**Paducah Gaseous Diffusion Plant (PGDP)**

**Docket No. 70-7001**

**Certificate Amendment Request-Autoclave Containment Valves Pressure Decay Testing**

**United States Enrichment Corporation (USEC)  
Proposed Certificate Amendment Request  
Autoclave Containment Testing  
Detailed Description of Change**

Figure 3.6-3. Simplified schematic of the C-360 autoclave and associated piping and valves.

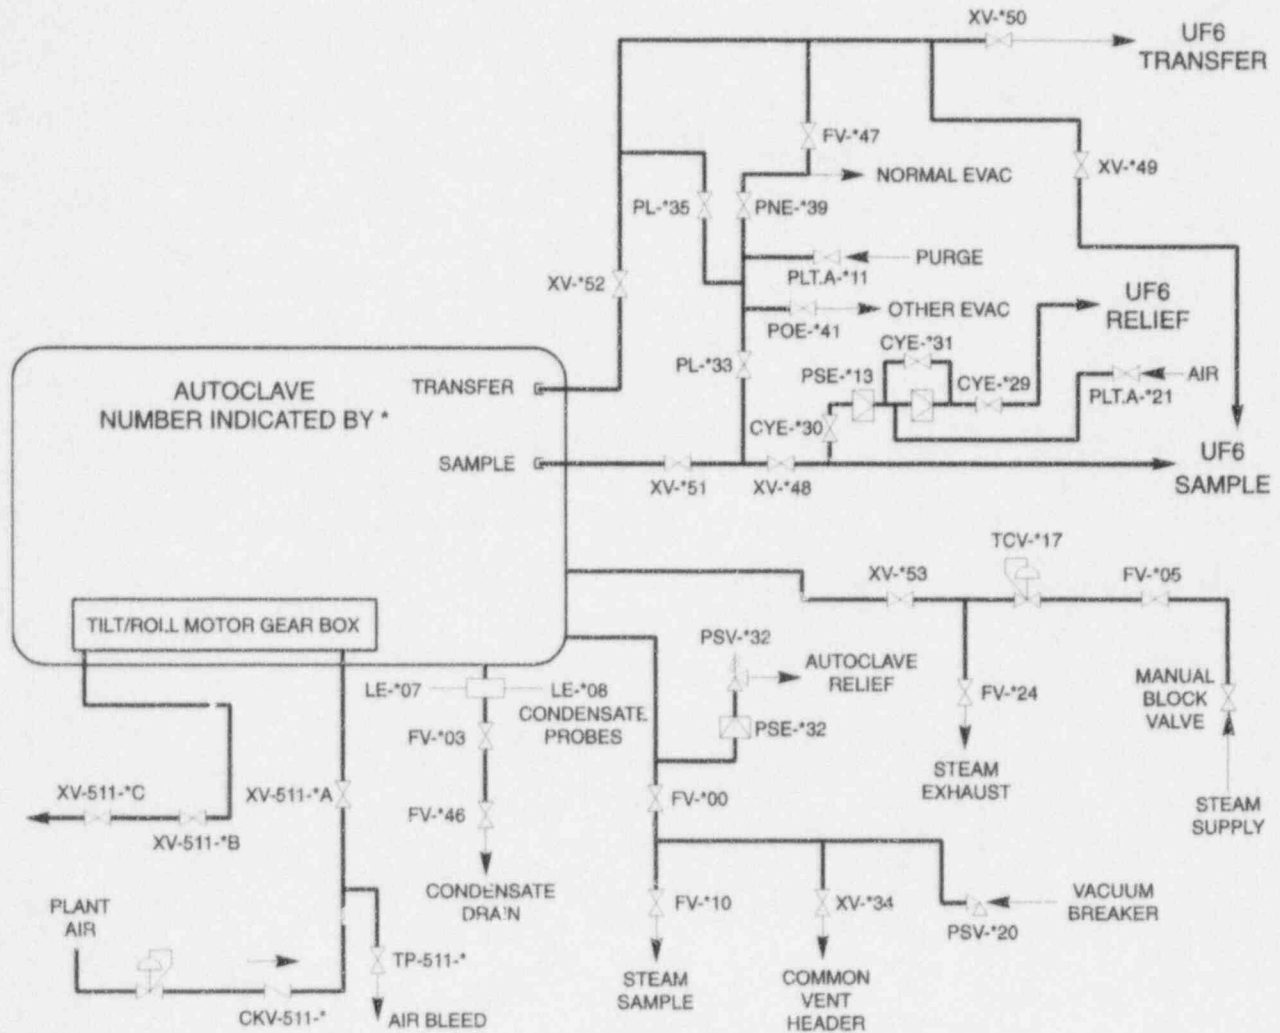
In conjunction with these changes, the piping configuration of the sampling and transfer autoclaves (C-360) is being modified. The UF<sub>6</sub> relief piping connection to the UF<sub>6</sub> sample line, has been moved to the outboard side of the UF<sub>6</sub> sample line outboard isolation valve (XV-\*48). The rupture disk in the UF<sub>6</sub> relief line (PSE-\*13), which acted as an isolation barrier in the previous configuration, will no longer perform this function. Figure 3.6-3 of the SAR has been modified to reflect this change and is included in Enclosure 2.
